AXIS OS Portal

Breaking changes

Changes in AXIS OS 12.0

- Disabled HTTP Port 80 redirects

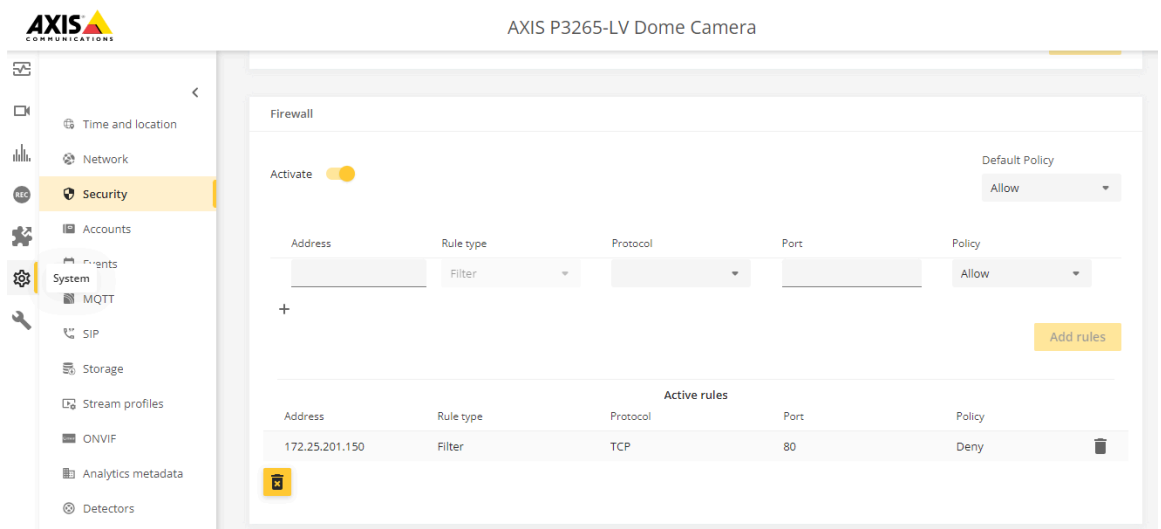
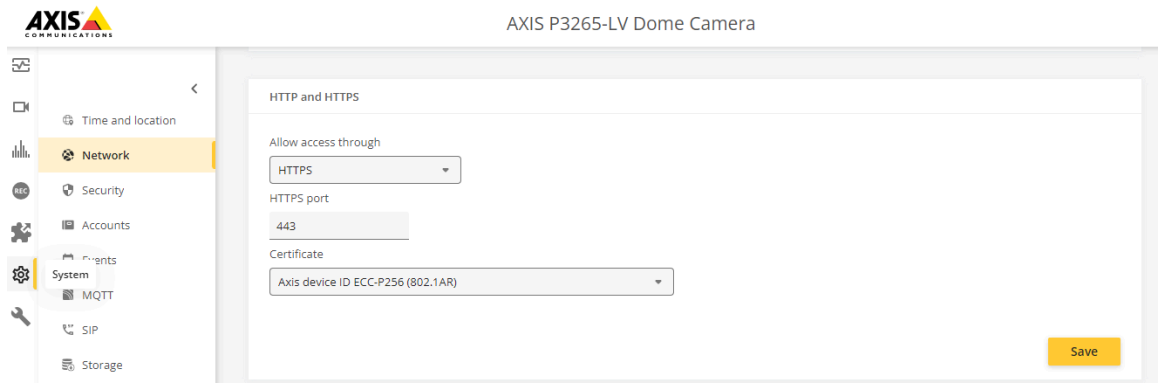
In previous security penetration tests, Axis was advised to disable HTTP Port 80 redirects in order to enhance security and to prevent information leakage. Currently, Axis devices are configured for HTTPS-only, but the HTTP port 80 redirects are

enabled to inform users/clients that communication is not permitted on port 80 and redirecting them automatically to port 443 instead. Axis will follow the general recommendation provided by third-party penetration test laboratories and will deactivate HTTP port 80 redirects when the device is set to HTTPS-only mode.

To test the possible impact, configure your Axis device for HTTPS only and configure a firewall rule in AXIS OS 11.9 as shown below, where the Axis device would effectively block communication on port 80 for a specific client trying to connect.

- Removal of root-privileges

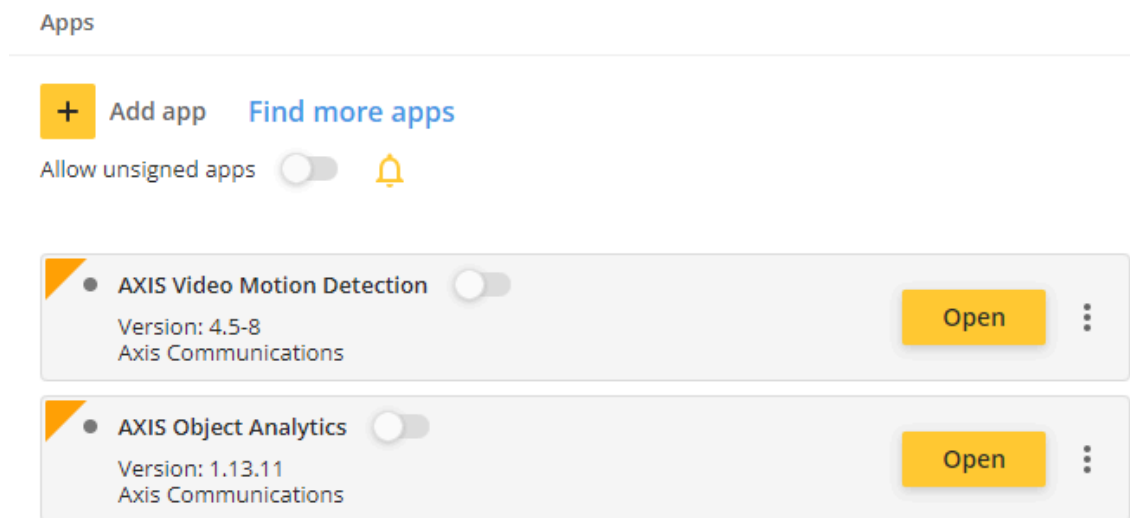
Root-privileged access to Axis products and ACAP applications has been removed indefinitely without the possibility to enable it. The previously available parameter in AXIS OS 11 to enable root privileges has been removed. This change applies to the factory default settings as well as when upgrading to AXIS OS 12 from any previous version of AXIS OS.

ACAPs with root privileges, will not work with AXIS OS 12.0 or higher. Check the installed ACAP applications carefully!

Make sure they are working properly. If possible, select the LTS 2024 track.

- **Removal of ACAP Computer Vision SDK support**

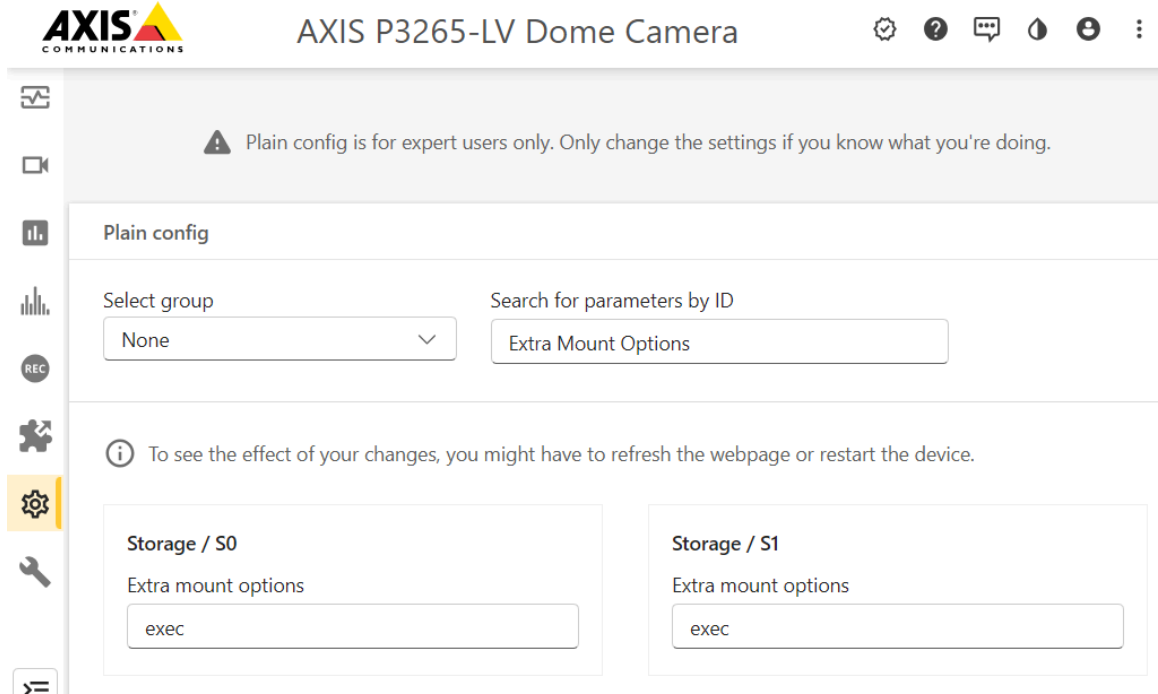
The ability to enable ACAP Computer Vision SDK support will be removed for the listed products because they only have 1 GB of memory.

Applies to: AXIS D2210-VE, AXIS M3215-LVE, AXIS M3216-LVE, AXIS M5526-E, AXIS P1465-LE, AXIS P1465-LE-3, AXIS P3265-LV/-LVE/-V and AXIS P3265-LVE-3

Why is this change introduced? Running the Computer Vision SDK on the product will consume too much memory and may render the product inoperable.

How can it affect me? If you have an ACAP using the Computer Vision SDK, it will not work correctly with AXIS OS 12.0 or higher.
